**Subject:** Final Report on the Cooling Canal Study at the Florida Power and Light Turkey Point  
Power Plant - Directive 151025

# The Cooling-Canal System at the FPL Turkey Point Power Station

**Final Report**  
**May 2016**

### A Response to FPL Comments

Figure 12: Thermal efficiency of the cooling canal system

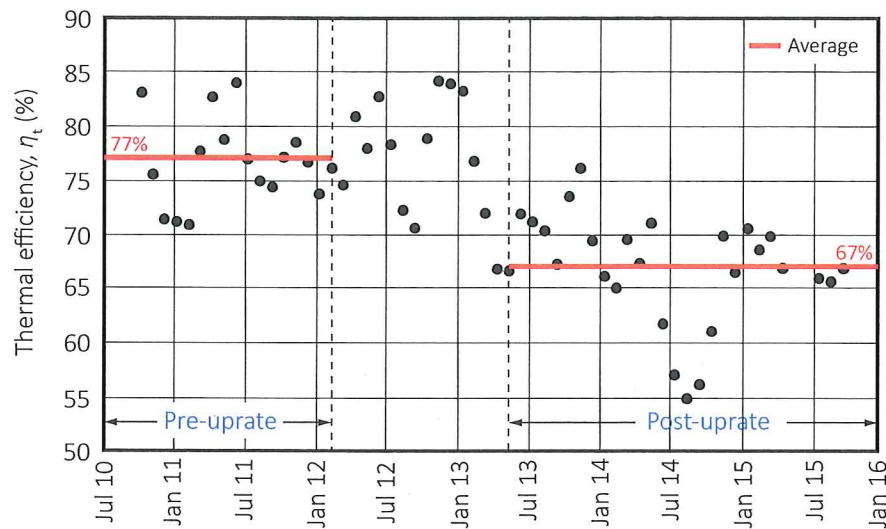
- A review of CCS heat exchange efficiency shows a decrease from a historic level of 75% efficiency to 65% in early 2013 followed by a decrease to 55% in early 2014. Significant blockages and sediment levels were noted, principally in the northern segments of the CCS. See Figure 3.

**Author Response:** Figure 3 provided by FPL shows a decrease in thermal efficiency between the pre-uprate and post-uprate time periods. The data shown in Figure 3 confirm the reported decrease in thermal efficiency contained in both the preliminary report and this final report. FPL indicates that significant blockages and sediment levels might be responsible for the decreased thermal efficiency, however, no data or analyses were provided to support this assertion. Whereas it seems reasonable to assert that blockages in the CCS are at least partially responsible for the reduced thermal efficiency in the CCS, it is equally reasonable to assert that increased temperatures in the CCS (due to increase power input from the power plant) is partially responsible for reduced thermal efficiency. The relative impacts of blockages and increased CCS temperature on thermal efficiency have not been analyzed by FPL, and therefore the extent to which removal of blockages will contribute to reduced temperatures in the CCS has not been addressed by FPL.

Figure 16: Salt inflow to CCS

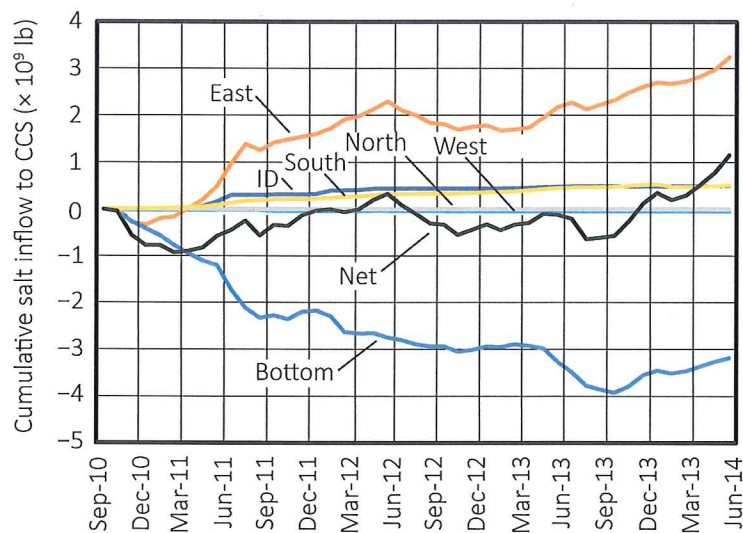
**Author Response:** In 2014, the extended period of no rainfall was the primary cause for high salinities measured in the CCS. As shown in Figure 16 and discussed in this report, the extended period of no rainfall was associated with a net seepage inflow of saline water from both the east-side and the bottom of the CCS, and these combined (yet interdependent) occurrences resulted in a steep trend of increasing salinity in 2014. Data collected subsequent to 2014 does not change the assertion regarding salinity dynamics that led to the increasing salinity in 2014. The cause of the salinity increase in 2014 is supported by the FPL mass balance model and is a data-driven conclusion. Subsequent to 2014, other factors contributing to salinity variations might have had a more dominant influence than the absence of rainfall. This occurrence is not contrary to the mass-balance analyses in the report. The lack of working rain gages to calibrate the NEXRAD data is certainly a concern, but there is insufficient data or analyses to assess the impact of this issue on the water-budget analyses presented in the report.
